# Access Compliance Report

## Public Rights-of-Way

### (Curb Ramps)

Intersection ID: 48960	Main Street: FRANKLIN_SQUARE_RD	Cross Street: BONROI_AV	Location: NW
ADA ID: 0A0BBB426406	Ramp Type: Perp	Initial Pass/Fail: Fail	Overall Compliance: No
		Severity Score: 1.25

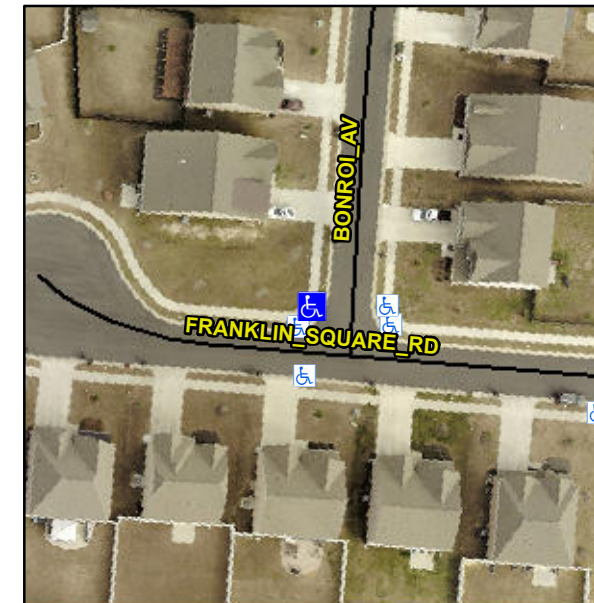
**Not Found, R304.5.3**

Compliance	Description	Data	Compliance	Description	Data
N/A	Ramp Length (in)	48.0	Yes	Ramp Slope (%)	8.0
Yes	Ramp Width (in)	48.0	No	Ramp XSlope (%)	5.0
N/A	Flare Type LT	N/A	N/A	Flare Type RT	N/A
N/A	Flare Slope LT (%)	N/A	N/A	Flare Slope RT (%)	N/A
N/A	Flare Traversable LT?	N/A	N/A	Flare Traversable RT?	N/A
N/A	Landing Length (in)	N/A	N/A	DWS Provided?	N/A
N/A	Landing Width (in)	N/A	N/A	DWS Contrast?	N/A
N/A	Landing Slope (%)	N/A	N/A	DWS Length (in)	N/A
N/A	Landing X Slope (%)	N/A	N/A	DWS Full Width?	N/A
N/A	Landing Curb? (Y/N)	N/A	N/A	DWS Offset (in)	N/A
N/A	Shared Landing?	N/A			
N/A	Gutter Ponding?	N/A	N/A	Gutter Slope (%)	N/A
N/A	Gutter Lip Ht (in)	1.0	N/A	Gutter X Slope (%)	N/A
N/A	Painted X Walk1?	No	N/A	Painted X Walk2?	N/A
	X Walk 1 Direction	To E		X Walk 2 Direction	N/A
N/A	X Walk 1 Width (in)	N/A	N/A	X Walk 2 Width (in)	N/A
	X Walk 1 Slope (%)	1.2		X Walk 2 Slope (%)	N/A
	X Walk 1 X Slope (%)	2.8		X Walk 2 X Slope (%)	N/A

**Remove & Replace Entire Ramp.**
